ZEE Systems, Inc.
AIRCRAFT AIR CONDITIONING and
HEATING SYSTEMS

SERVICE BULLETIN 59-000-1

- A. Effectivity: Dassault Falcon 10 aircraft with STC SA4843SW installed. This Service Bulletin may be accomplished concurrently with original STC equipment installation.

- B. Reason: To modify and upgrade the vapor cycle air conditioning system to use CFC free R-134a refrigerant.
- C. Description: This Service Bulletin gives instructions for converting the Vapor Cycle air conditioning system from R-12 (Freon) to the EPA accepted R-134a (HFC-134a) refrigerant. This conversion consists of discharge of the system, parts replacement and recharging the system.

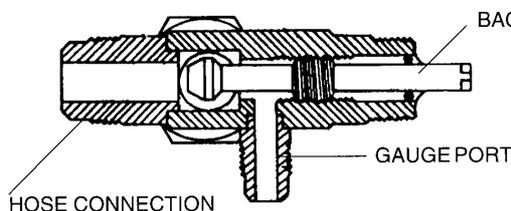
- a. Zee P/N: DS200U137-10 Union in the tube from the evaporator. Apply a light film of the refrigerant oil to the flare of the union to help seat the seal area. Use a backup wrench and tighten.
